ADDENDUM NO. 2

November 7, 2022

CENTRAL HIGH SCHOOL HVAC IMPROVEMENTS

This Addendum forms a part of and modifies the Bidding Requirements, Contract Forms, Contract Conditions, the Specifications, and the Drawings dated October 3, 2022, by TowerPinkster. Acknowledge receipt of the Addendum in the space provided on the Bid Form. Failure to do so may subject the Bidder to disqualification.

Refer to Sheet(s): A 104 (reissued)

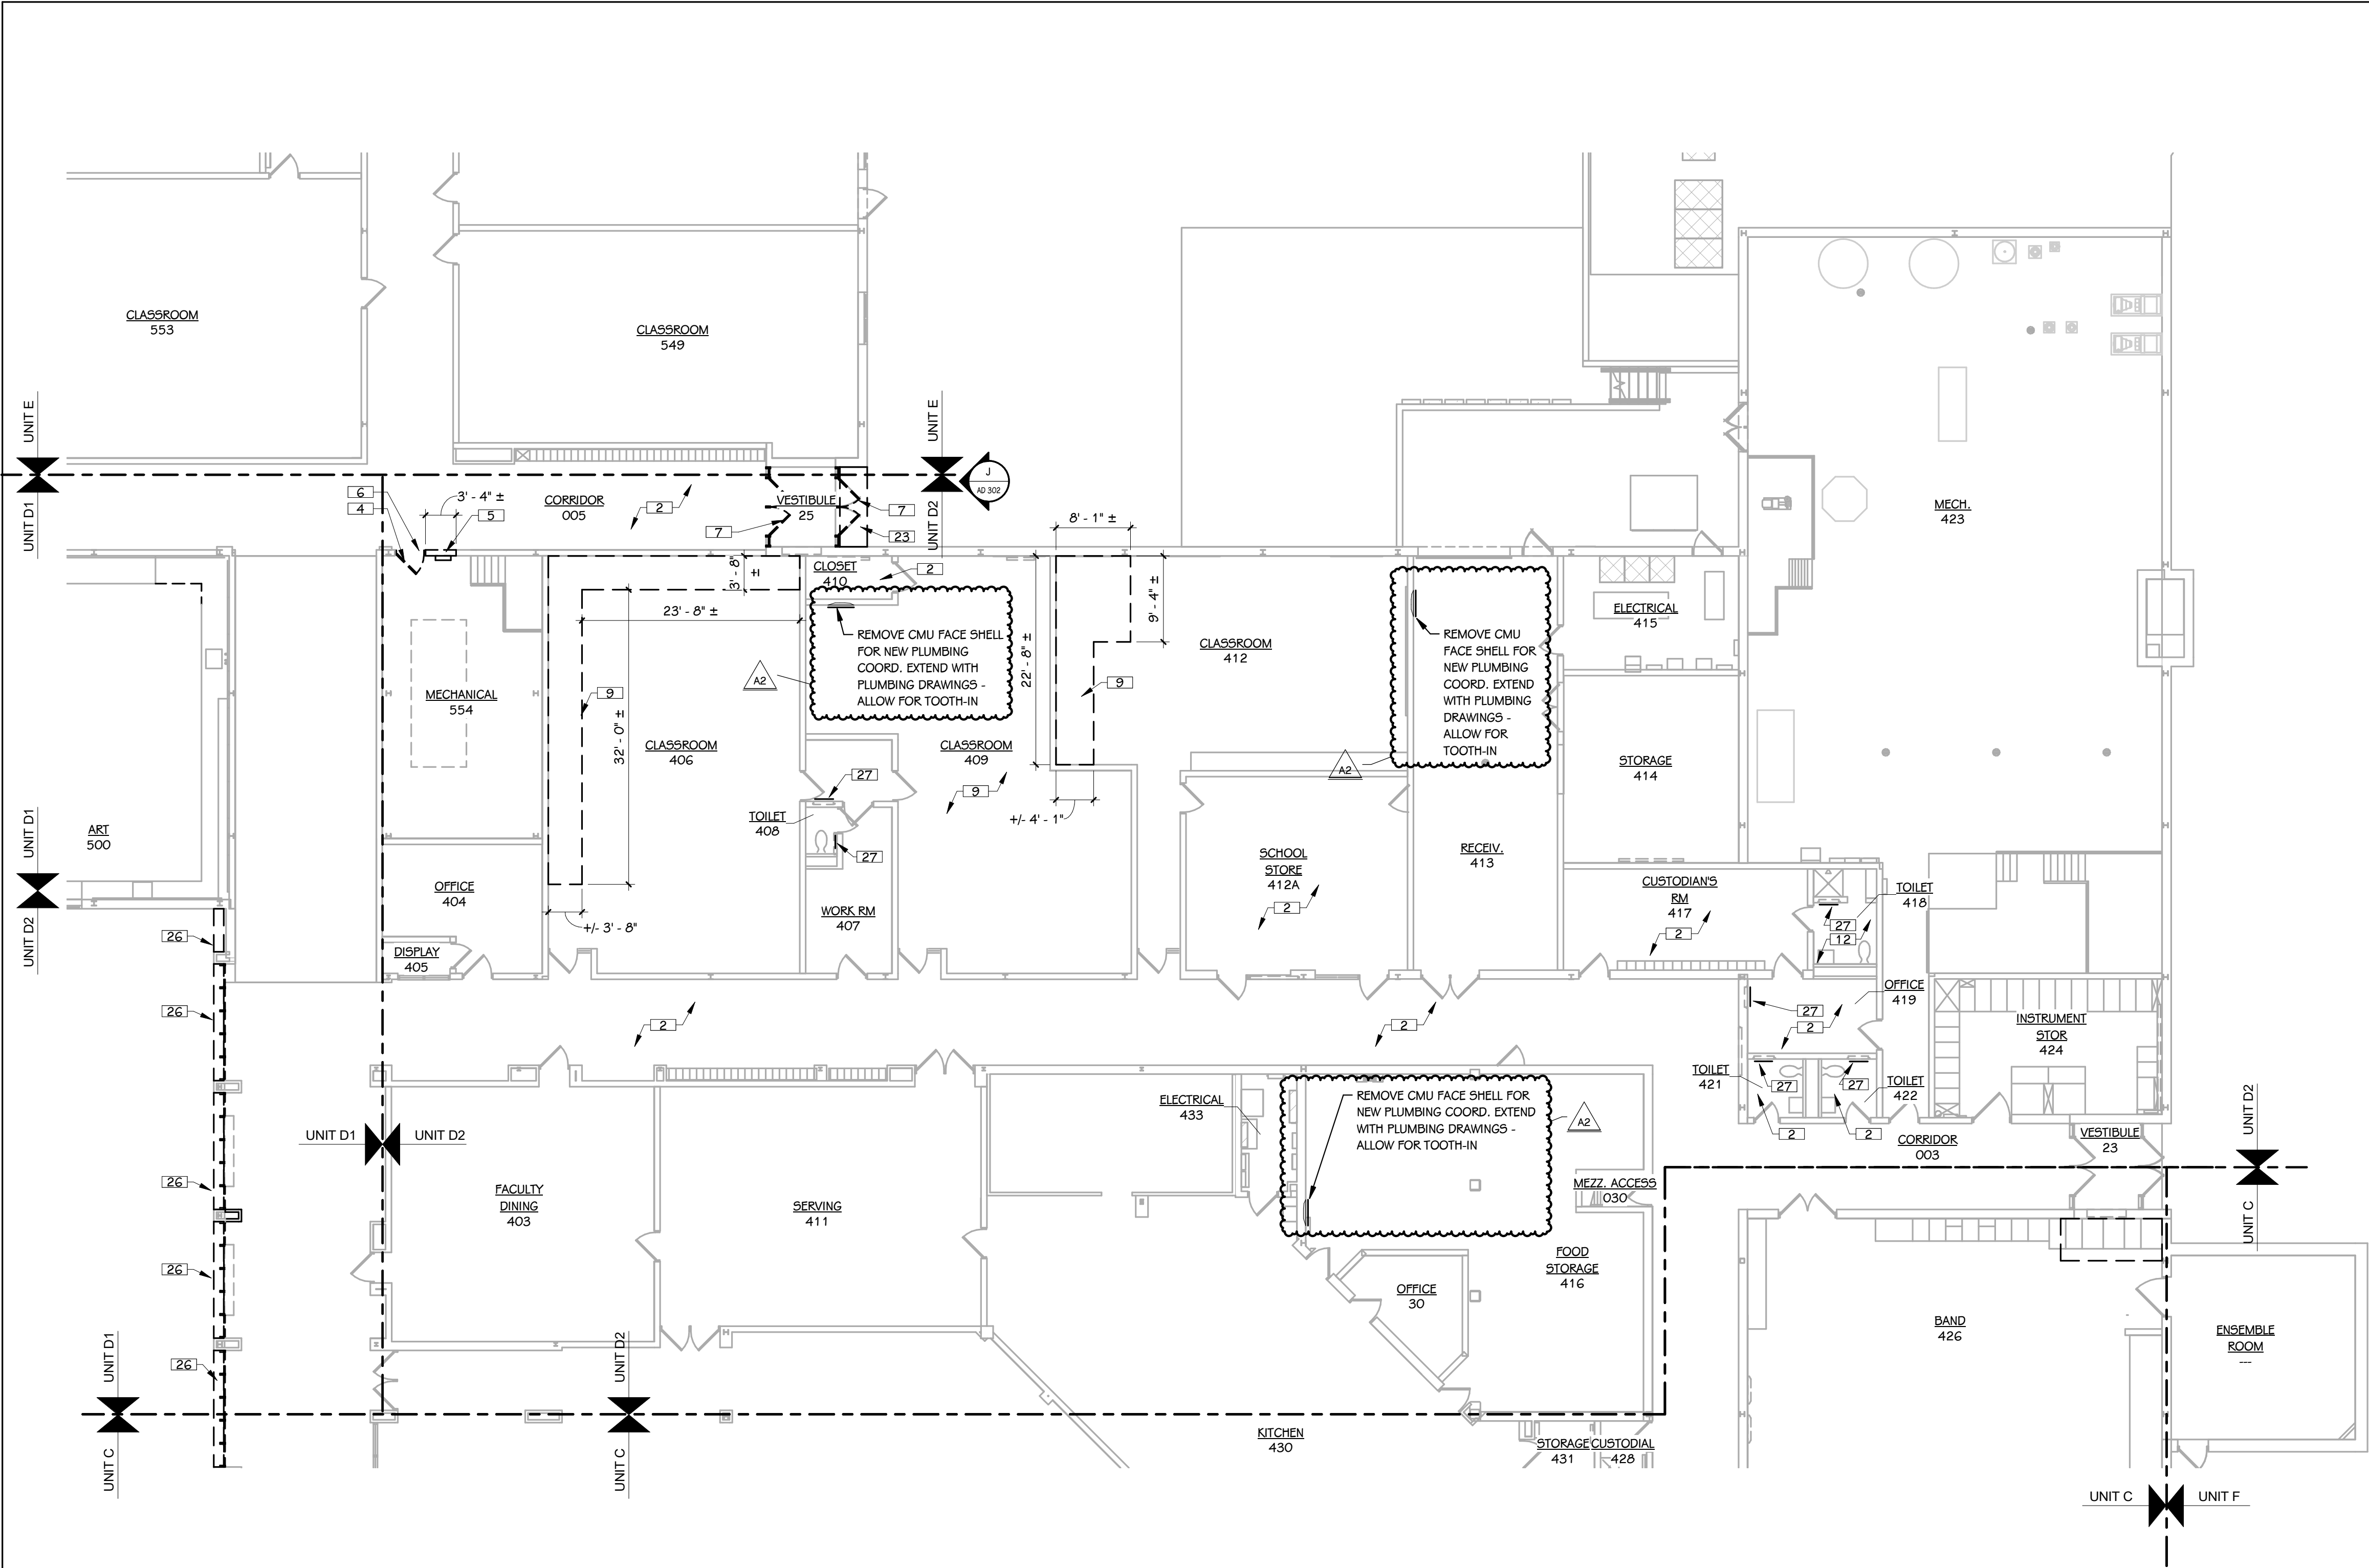
ADD-2 Item No. D-7 - Added Through Roof Penetrations

Added two roof penetration demo, flashing, steel framing, etc.

SHEET NUMBER
AD 102D2
21-806.00

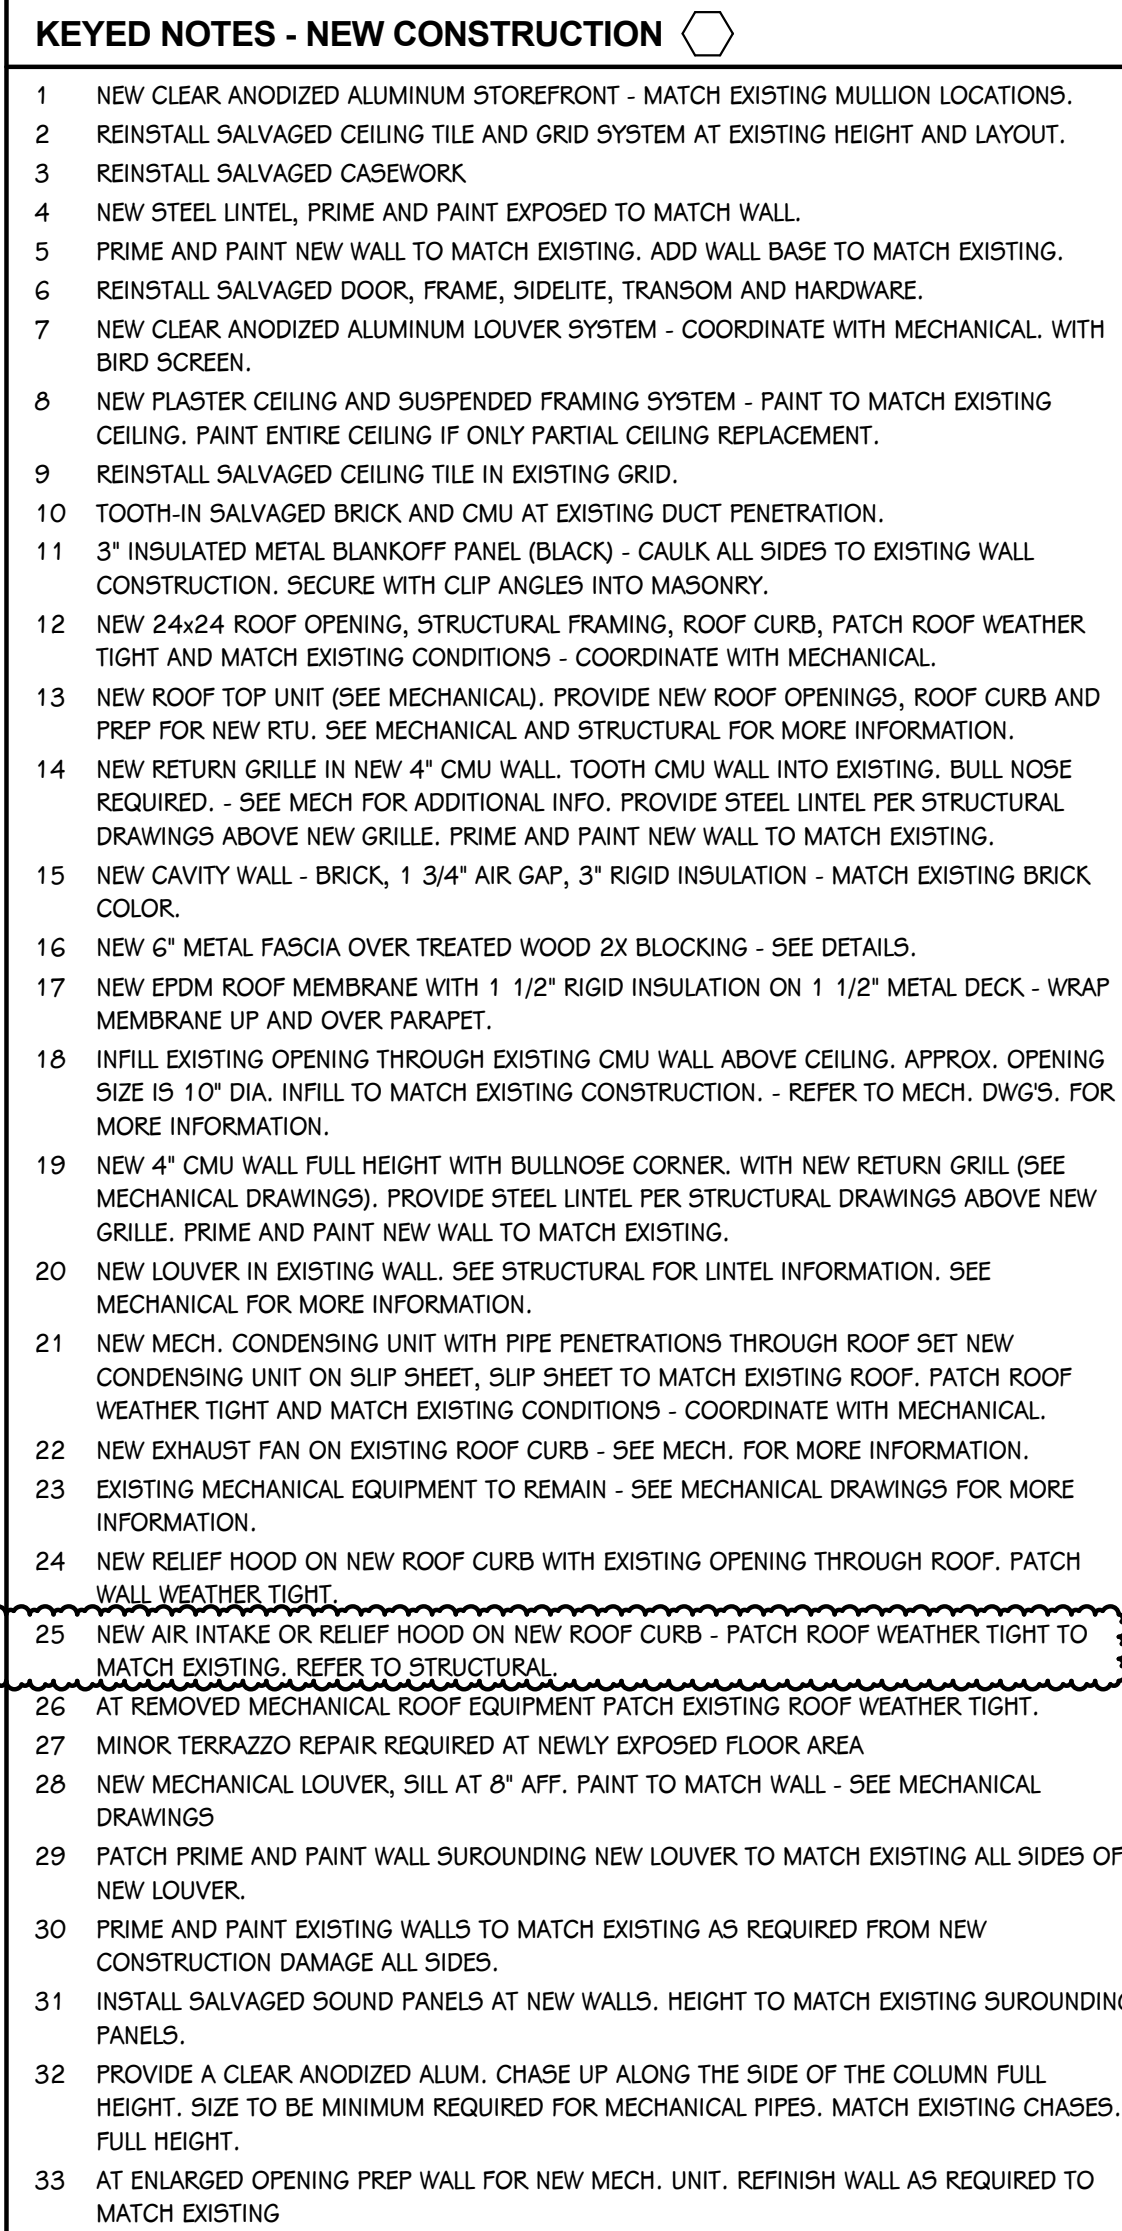
ADD-2 Item No. D-8 - Added Multiple Pipe Routings Through Walls

Added multiple face shell removal and reinstallation of new. Tooth-in, prime and paint to match existing.
